(B) CANCELLED AFTER 15 JUNE 1982 SUPERSEDED BY MS21919 SEE TABLE ABOVE

APPROVED 1 JULY 67 REVISED (A) 2 DEC 1970 (B) 15 JUNE 1982

P.A. NAVY - AS Other Cust USAF - 82 ARMY - AV	TITLE CLAMP, LOOP, CUSHIONED, WEDGE, FLUID RESISTANT, 500°F, CRES, TYPE III, CLASS B	MILITARY STANDARD MS21105
PROCUREMENT SPECIFICATION MIL-C-8956	SUPERSEDES: MS21219 IN PART, MS21105(ASG)	SHEET 1 OF 1

ACCEPTABLE WEDGE CONFIGURATIONS

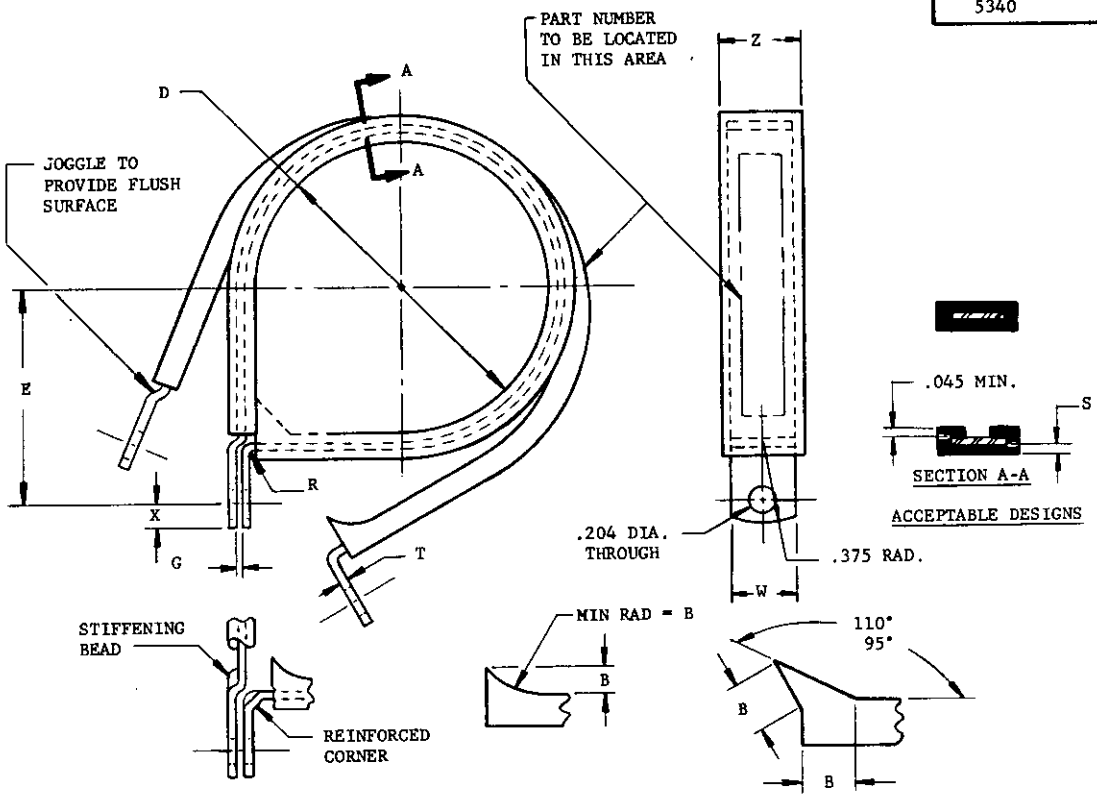
(B) NOTE: WHEN POSSIBLE, ENGINEERING DESIGNERS SHOULD REVIEW THE APPLICATION OF THE CANCELLED PART FOR POSSIBLE SUBSTITUTION OF M85052/3-( ). THIS PART HAS SUPERIOR CUSHION TEAR RESISTANCE BUT SHOULD BE USED ONLY IN AREAS NOT CONTAMINATED WITH FUEL OR HYDRAULIC FLUIDS AT ELEVATED TEMPERATURES OF 275°F TO 500°F. SEE MIL-C-85052/3 FOR COMPLETE APPLICATION INFORMATION.

INTERCHANGEABILITY TABLE		
CANCELLED PART	REPLACEMENT PART SIZES -2 TO -48	REPLACEMENT PART SIZES -50 TO -66
MS21105-( )	MS21919WCJ( )	MS21919CJ( )
